SUNDRY NOTICES AND REPORTS ON WELLS

**Plugging and Abandonment Procedure  
Horseshoe Gallup Unit No. 10  
Attachment "A"**

Re: Permanent Abandonment

Well: 10 Horseshoe Gallup Unit

WELL NAME 10 HGV  
 SEC, TWN, RNG. 30-31N-16W

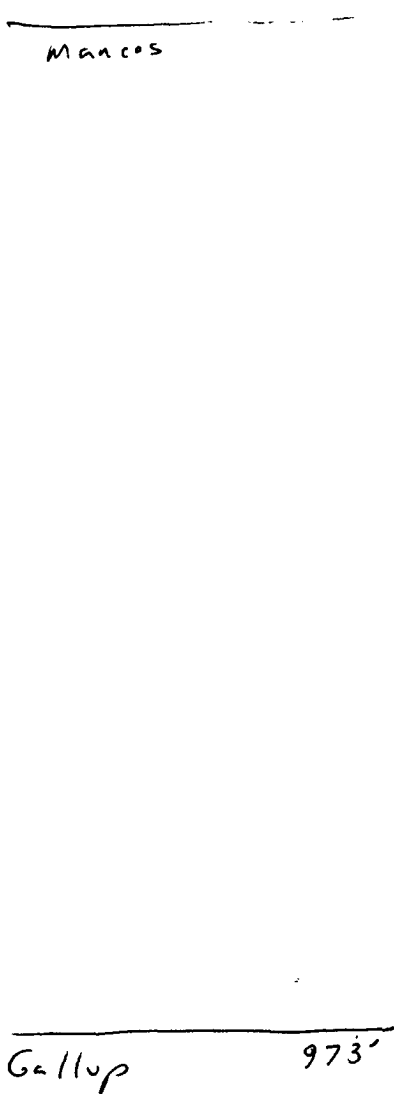
Plug 157' - surface 50 SKS  
 $8\frac{5}{8}"$  24#  
 107'  
 $157 / 7.299 (1.18) = 18 \text{ SKS}$   
 $50 / 5.7719 (1.18) = 7 \text{ SKS}$   
 $107 / 5.192 (1.18) = 17 \text{ SKS}$   
42 SKS

TOC  $\approx$  675' 75%

$(1180 - 923) + 50 / 7.299 (1.18) = 36 \text{ SKS or greater}$

Plug 1180 - ~~1055~~  
 923

a) Bring the top of the Gallup plug to 923'.

b) Place the Surface plug from 157' to surface inside and outside the 5 ½" casing.
